## Modification Bulletin

Model: 3000-sheet F	Finisher for NAD 30S/30/40	Date	e: 30-Jun-98	No: 1	
Modified Article: F	ront Positioning Fence, etc.	Prepared by: S.Tomoe			
From: QAC Field Inf	ormation Dept.				
Reason for	☐ Parts catalog correction	Uendor ch	ange 🔲 To n	neet standards	
Modification: ☐ To facilitate assembly		☐ To improve reliability ( )			
	☐ Part standardization	oxtimes Other

To prevent the positioning fence in the staple tray from coming out of position, the following parts have been changed.

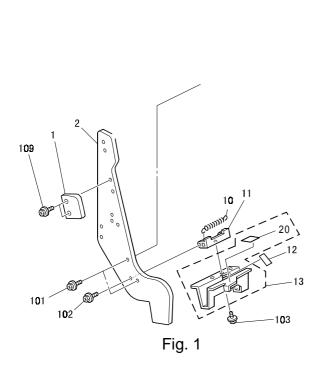
Note 1: Refer to Fig. 1.

Old part	New part	Description	Qty	Int	Page	Index	Note
number	number						
A6974210	A6974211	Front Positioning Fence	1	X/O	15	13	1
A6974205	A6974207	Rear Positioning Fence	1	X/O	15	14	
	A6974213	Decal – Front Positioning Fence	1		15	20	1
	A6974149	Decal – Staple Unit Holder	1		17	41	2

Fig. 2

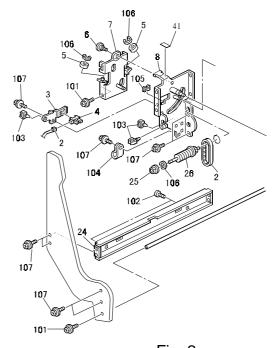
Note 2: Refer to Fig. 2.

#### - For your reference -

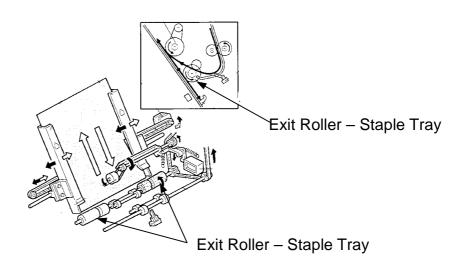
To prevent non-stapling when there are stacking problems with face-curled output, the width of the outer rollers has been changed from 66 mm to 51 mm.

Stacking problems occur with curled copies, because the trailing edge of the copy gets stuck on the brush rollers instead of being stacked properly.

Old part number	New part number	Description	Qty	Int	Page	Index	Note
A697-2135	A697-2146	Exit Roller – Staple Tray	2-2	X/O	11	14

#### Paper Curl Kit: A697-9512

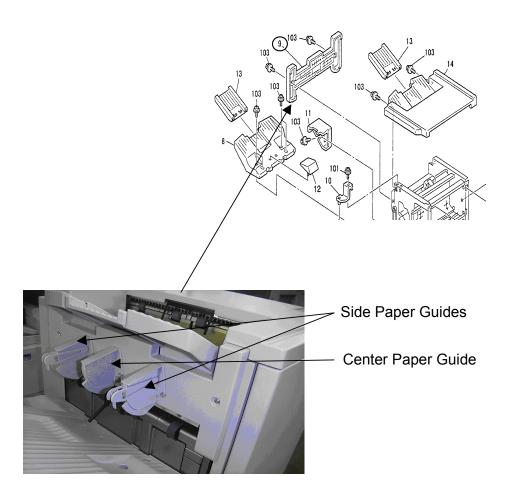
The paper curl kit P/N: *A697-9512* has been registered as a service part. The screw holes for the curl kit have been added to the left upper cover. The part number of the cover has been changed.

Note: This paper curl kit is only for the SR730 installed on the NAD.

Do not use this kit for the SR730 installed on the SP5.

Old part	New part	Description	Qty	Int	Page	Index	Note
number	number						
-	A697-9512	Paper Curl Kit	1	-	-	-	-
A697-6181	A697-6182	Left Upper Cover	1-1	X/O	7	9	-

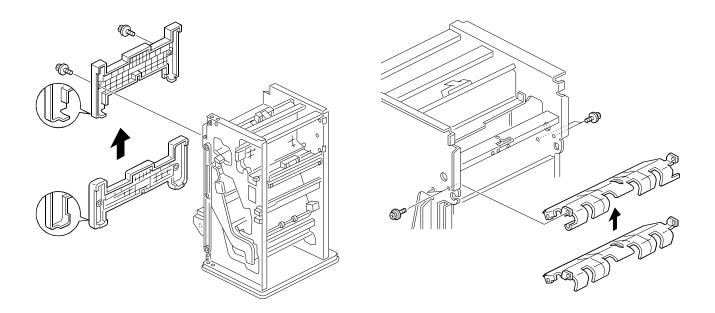
As the fed-out paper is being stacked in the Shift Tray, the trailing edge rubs past the edge of the Left Upper Cover, causing the stack to become disordered. To prevent this, a small section of the vertical plate attached to the inside of the cover has been cut out. In addition, a small, rounded section has been added to the edge of the Lower Exit Guide to improve stacking.

Old part	New part	Description	Q'ty	Int	Page	Index	Note
number	number						
A6976182	A6976183	Left Upper Cover	1-1	X/O	7	9	
A6972180	A6972181	Lower Exit Guide	1-1	X/O	25	17
